Access Compliance Report

Public Rights-of-Way

(Curb Ramps)

Intersection ID: 26038	Main Street: ELM_LN	Cross Street: PINEVILLE-MATTHEWS_RD	Location: N
ADA ID: 0900A981164F	Ramp Type: Perp	Initial Pass/Fail: Fail	Overall Compliance: No
Severity Score: 18.75			
Codes/Mitigation Info/Possible Solution		Field Measurements/Component Compliance

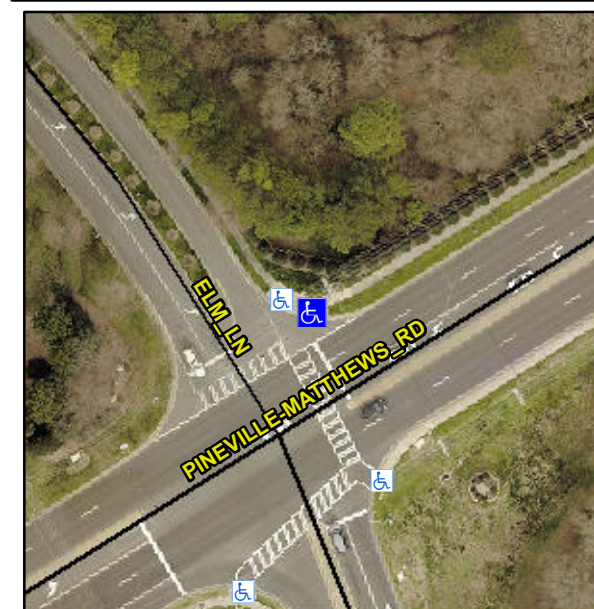
Not Found, R304.5.1, R304.5.3

Compliance	Description	Data	Compliance	Description	Data
N/A	Ramp Length (in)	105.0	Yes	Ramp Slope (%)	6.8
No	Ramp Width (in)	35.0	No	Ramp XSlope (%)	3.1
N/A	Flare Type LT	N/A	N/A	Flare Type RT	N/A
N/A	Flare Slope LT (%)	N/A	N/A	Flare Slope RT (%)	N/A
N/A	Flare Traversable LT?	N/A	N/A	Flare Traversable RT?	N/A
N/A	Landing Length (in)	N/A	N/A	DWS Provided?	N/A
N/A	Landing Width (in)	N/A	N/A	DWS Contrast?	N/A
N/A	Landing Slope (%)	N/A	N/A	DWS Length (in)	N/A
N/A	Landing X Slope (%)	N/A	N/A	DWS Full Width?	N/A
N/A	Landing Curb? (Y/N)	N/A	N/A	DWS Offset (in)	N/A
N/A	Shared Landing?	N/A			
N/A	Gutter Ponding?	N/A	N/A	Gutter Slope (%)	N/A
N/A	Gutter Lip Ht (in)	N/A	N/A	Gutter X Slope (%)	N/A
N/A	Painted X Walk1?	No	N/A	Painted X Walk2?	N/A
	X Walk 1 Direction	To SE		X Walk 2 Direction	N/A
N/A	X Walk 1 Width (in)	N/A	N/A	X Walk 2 Width (in)	N/A
	X Walk 1 Slope (%)	0.9		X Walk 2 Slope (%)	N/A
	X Walk 1 X Slope (%)	0.2		X Walk 2 X Slope (%)	N/A

Remove & Replace Entire Ramp.
